Recommendations from Imtac on public realm proposals for Belfast Streets Ahead Phase 5

(November 2018)

About this report

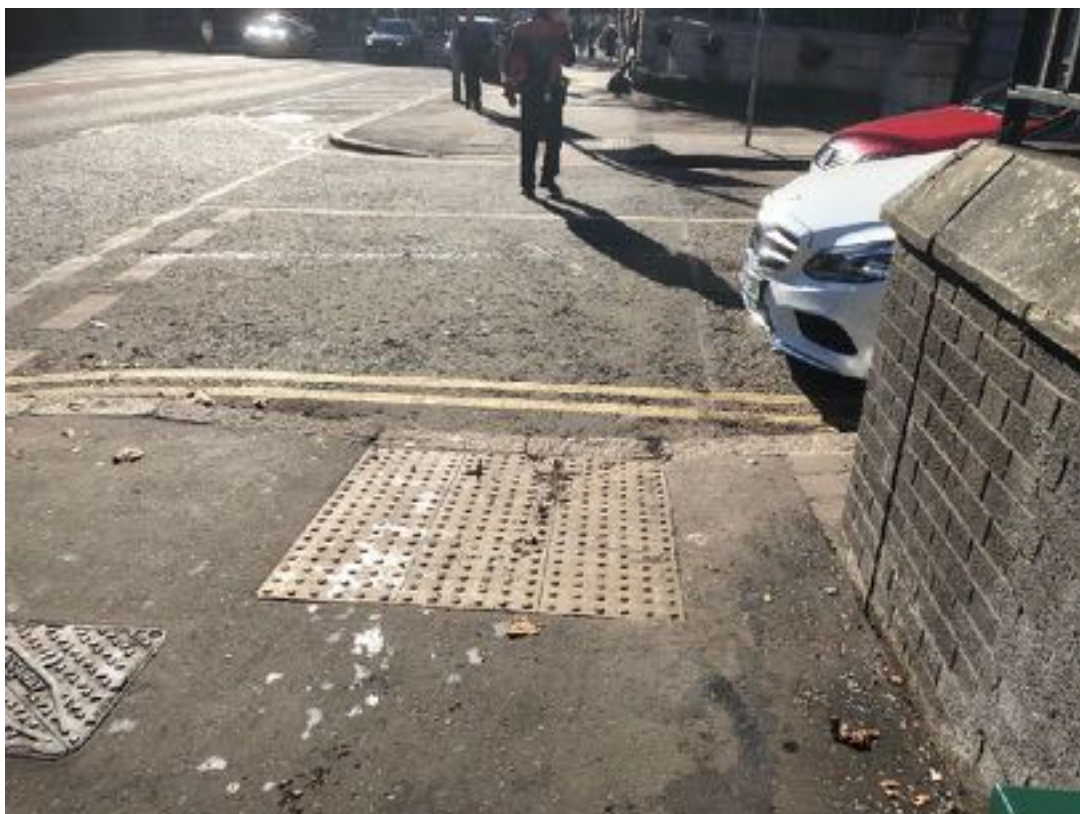
To the south of this point there adjacent to the entrance of RBAI is a controlled crossing across the northbound lanes of College Square East to the large central traffic island. Both the provision of tactile paving and location of control boxes is excellent at this crossing.

This section includes crossings on Donegall Pass and Botanic Avenue close to Shaftesbury Square.

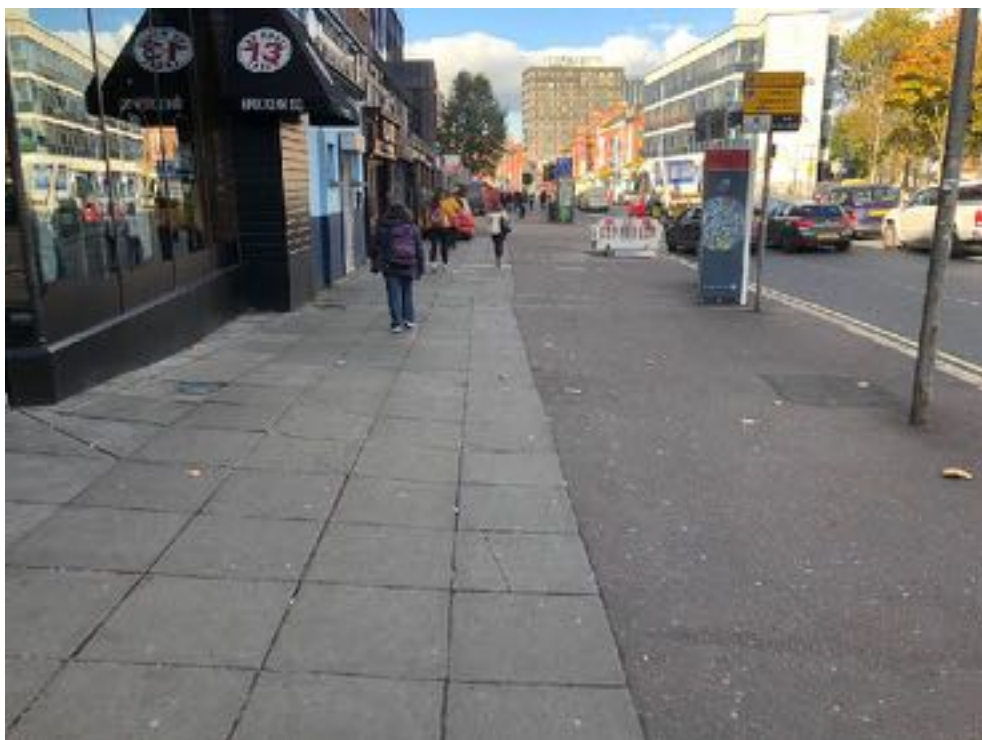
There is controlled crossing on the western side of Shaftesbury Square beside the offices of Volunteer Now. The tactile paving on both sides has been laid incorrectly with the tail to the left rather than the right, however control boxes are included on both left and right signal columns.

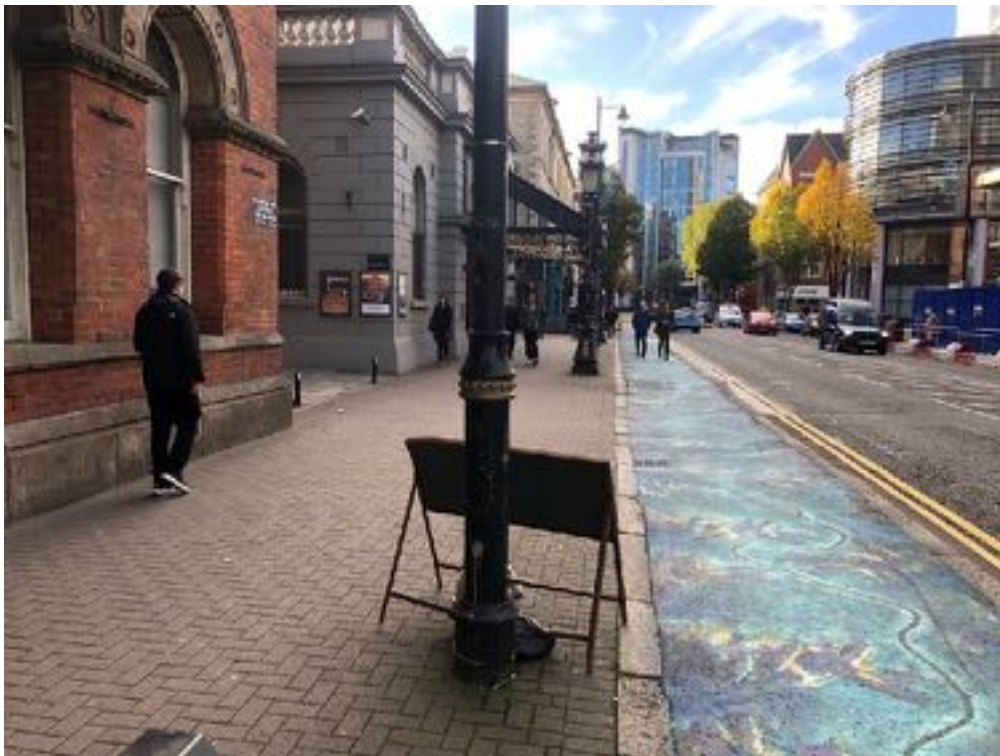
There is an in-line uncontrolled crossing across the junction with Clarence Street. Different colours of tactile paving is used on the southern side. On the northern side tactile leads directly into pavement cafe screening.

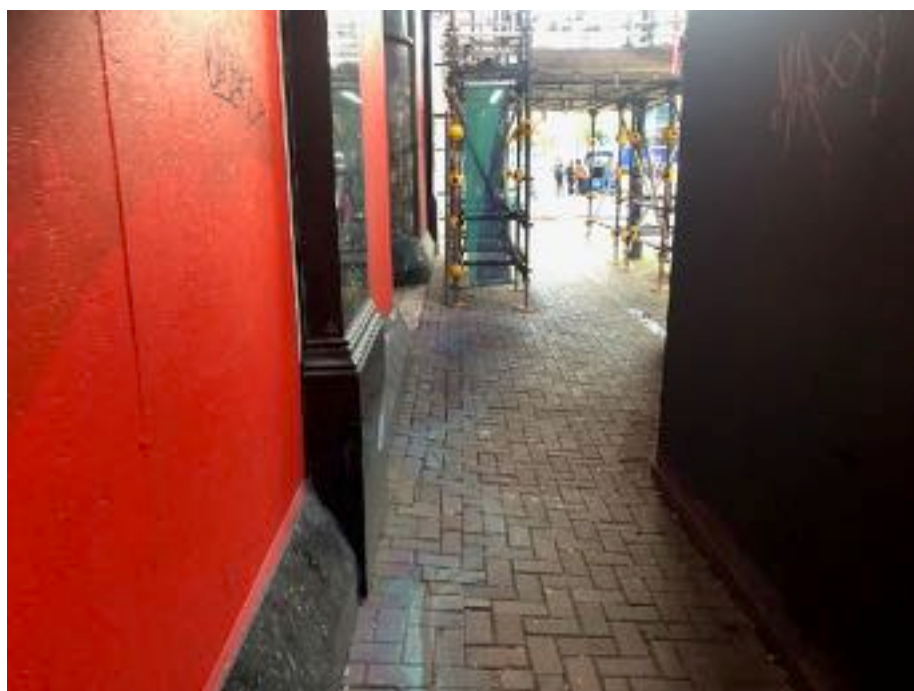
There is an in-line uncontrolled crossing across Bedford Street north of Franklin Street which includes a small traffic island. The tactile paving has been laid incorrectly on the eastern footway, extending to the building line. Although laid correctly outside the Grand Central contrast is not good.

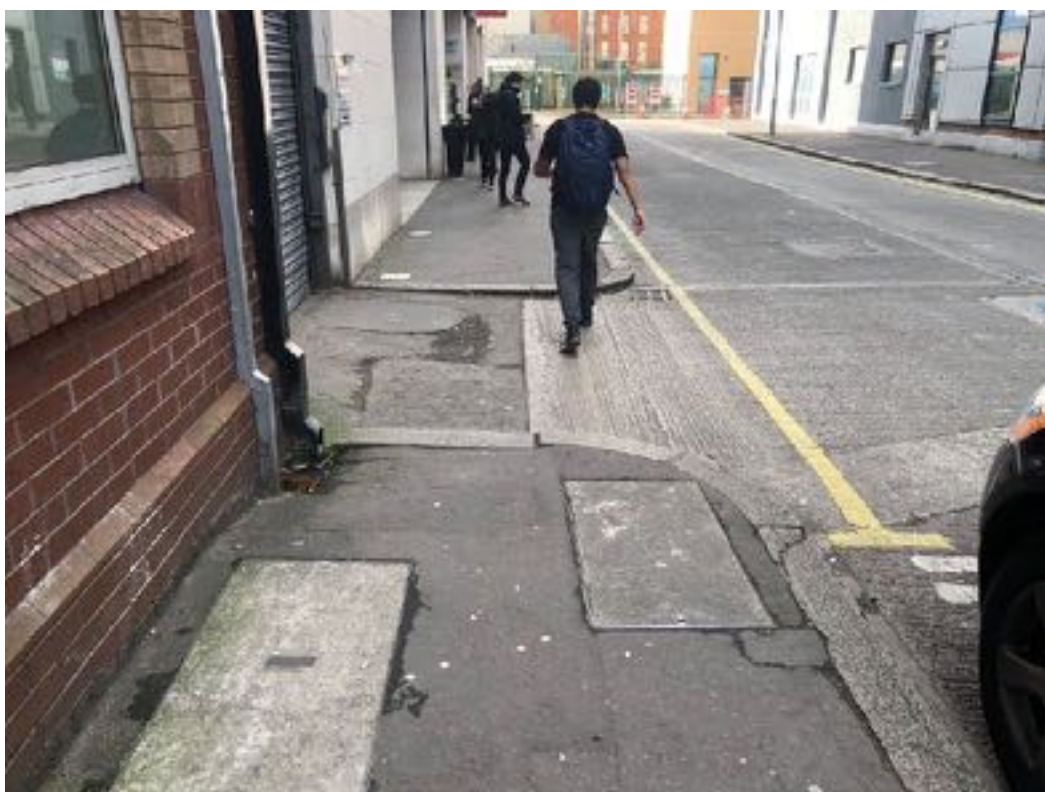
There is an in-line uncontrolled crossing across the junction with Clarence Street West. The tactile paving is damaged and uneven and different coloured tiles have been used.

Brunswick Street and Blackstaff Square

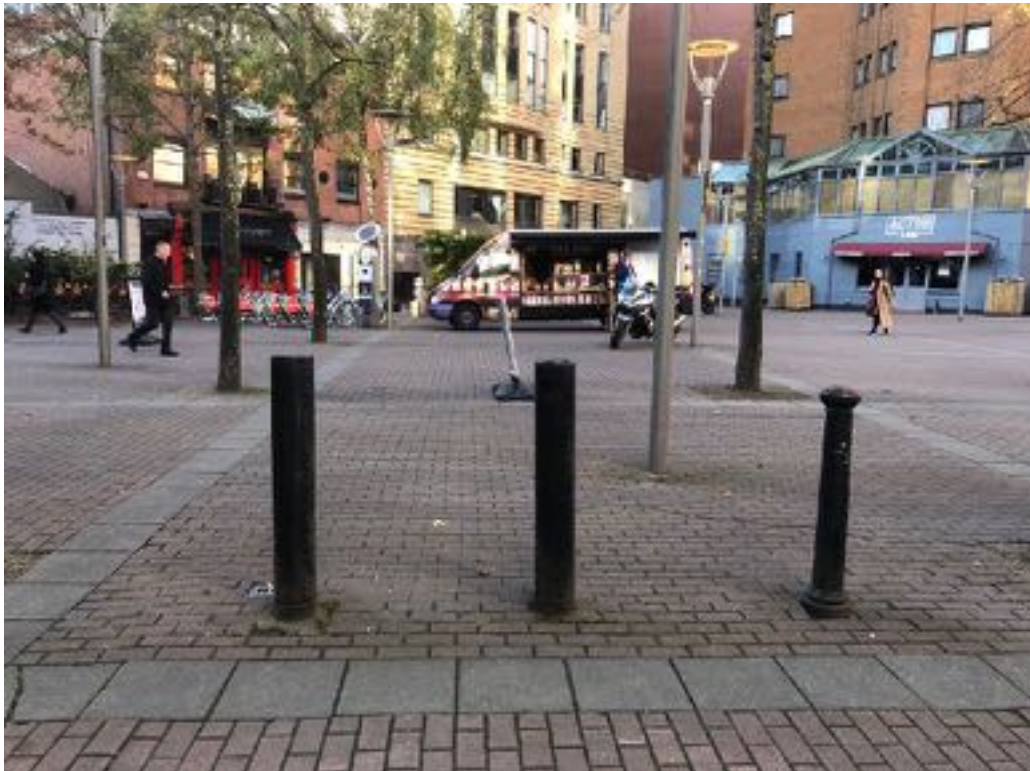
There is a table junction where Franklin Street, Amelia Street and Brunswick Street meet Blackstaff Square. Although tactile paving has been provided to highlight crossing points along the extremes of the raised table, there remain large sections of flush access between the footway and carriageway without any tactile surface.

The design of the junction makes its safe use by people with a visual impairment difficult or impossible. Other participants in the audit felt the layout was confusing and unsafe.

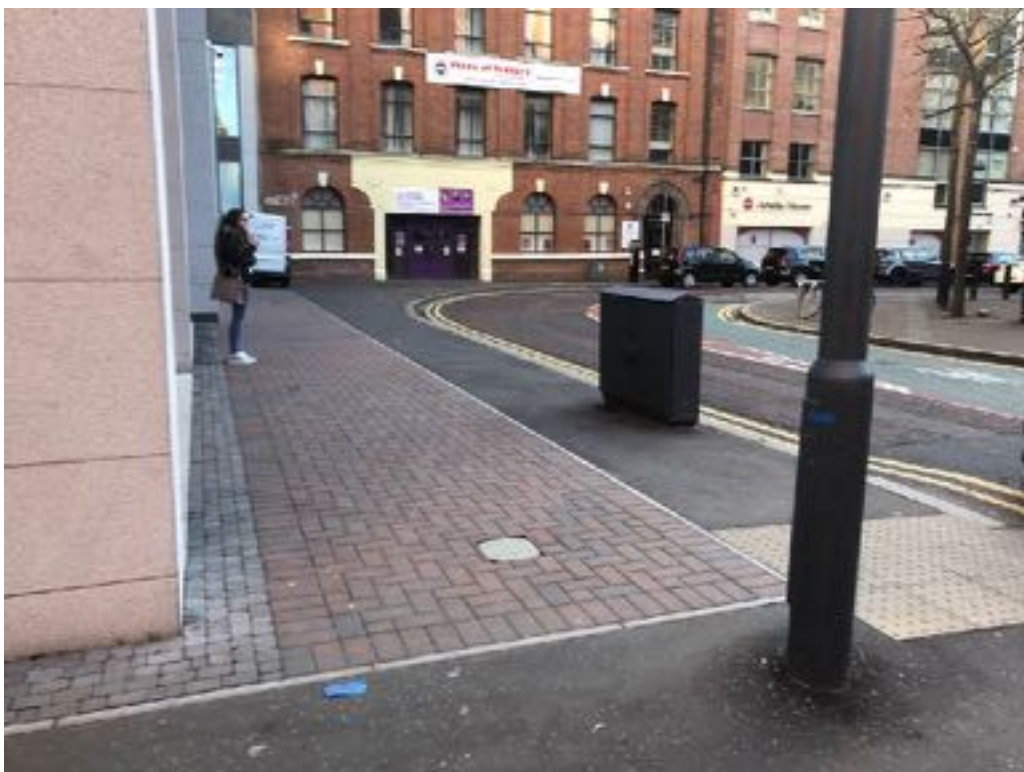
An A-Board obstructs the footway approaching Blackstaff Square.

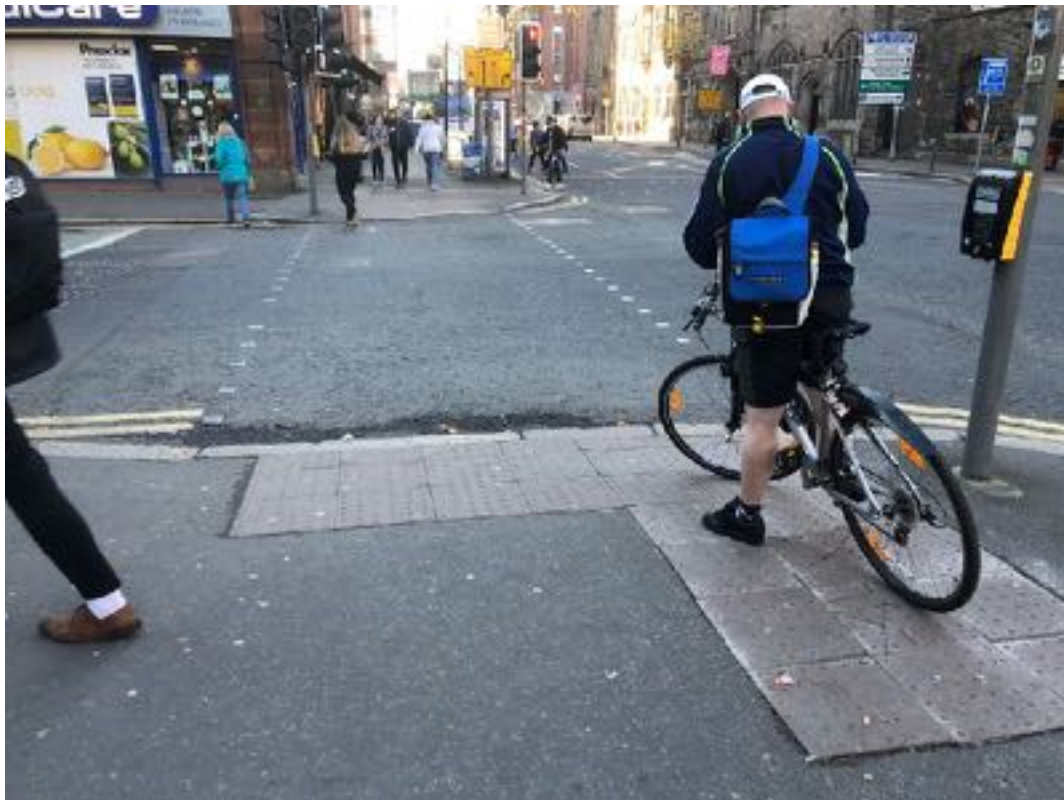
The orientation of a cycle parking hoop creates an additional hazard on an already cluttered footway.
